## IMPORTANT SAFETY RECALL

NHTSA Safety Recall No. 14V-745
------------------------------------

# Customer Service Notice

## Pressure Switch Inspection

**Figure 1 — Tank Manifold Location**

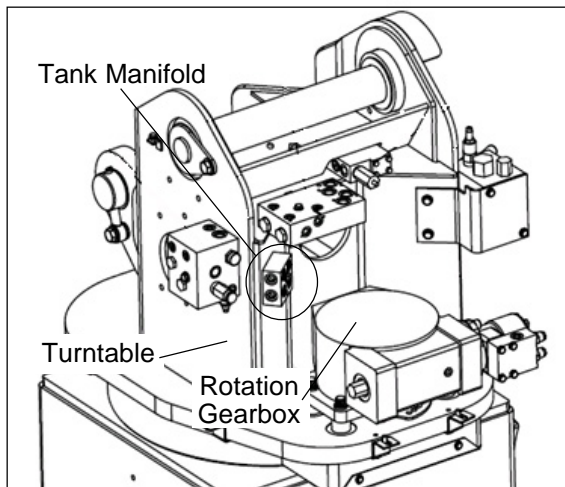
1. Position the unit on a level surface, apply the parking brake and chock the wheels. Engage the unit's hydraulic system. Properly set the outriggers. Disengage the unit's hydraulic system
2. Remove both side covers on the turntable.
3. Locate the tank manifold on the rear of the turntable (refer to Figure 1).

**Figure 2 — Switch Location**

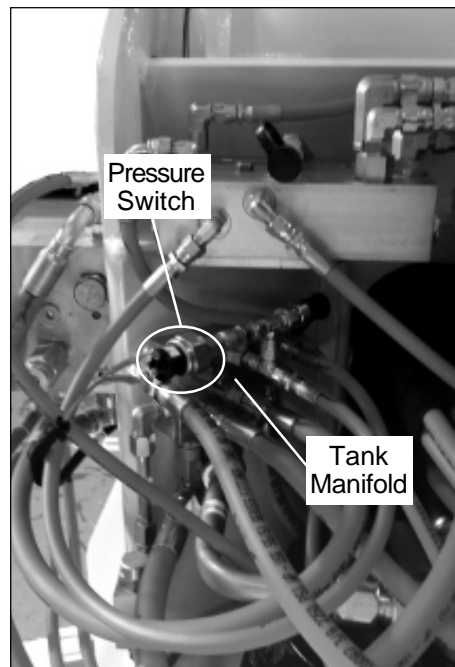
4. Look to see if there is a switch located in the tank manifold (refer to Figure 2).

5. If there is no pressure switch in the tank manifold, order the Backpressure Interlock Kit, part number 970142159. If there is a pressure switch, continue to Step 6.

**Figure 3 — Adjustable Switch**

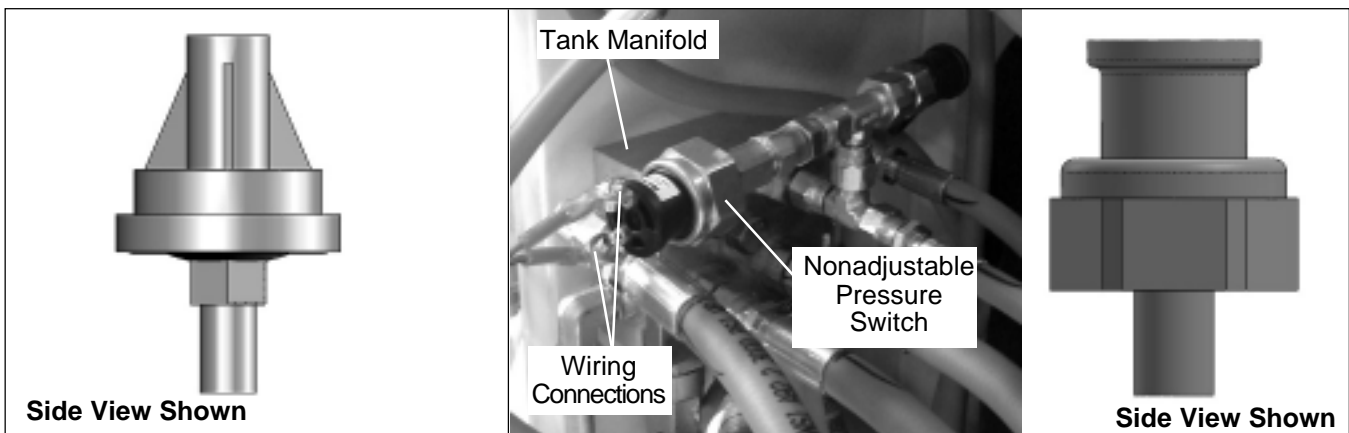
6. Look at the switch. If the switch is adjustable, the side view should look like a cone (refer to Figure 3). If the switch is adjustable, order the Switch Replacement Kit, part number 990009464. If the switch is nonadjustable, it should look like a cylinder (refer to Figure 4).

7. If the pressure switch is nonadjustable, the inspection is complete and no further action is required.
8. Reinstall the turntable covers. Engage the unit's hydraulic system, stow the unit, if needed, and retract the outriggers. Return the unit to service.
9. Complete the inspection form at the end of this CSN and return it to Altec.

Investigation has found that a pressure switch can be installed in the original hydraulic circuit to relieve this backpressure. Some units may have a field-installed adjustable pressure switch to help eliminate this condition. Any adjustable switch must be replaced with one that is not adjustable. Customers must inspect the unit, using the Procedure beginning on Page 2, to determine if the switch was already installed and if it is adjustable. After the inspection is complete, order the correct kit from the list below. The kit should be installed no later than 120 days from the receipt of this CSN or at the next preventive maintenance interval, whichever is earlier. Call 1-877-GO ALTEC (1-877-462-5832) to order the correct kit.
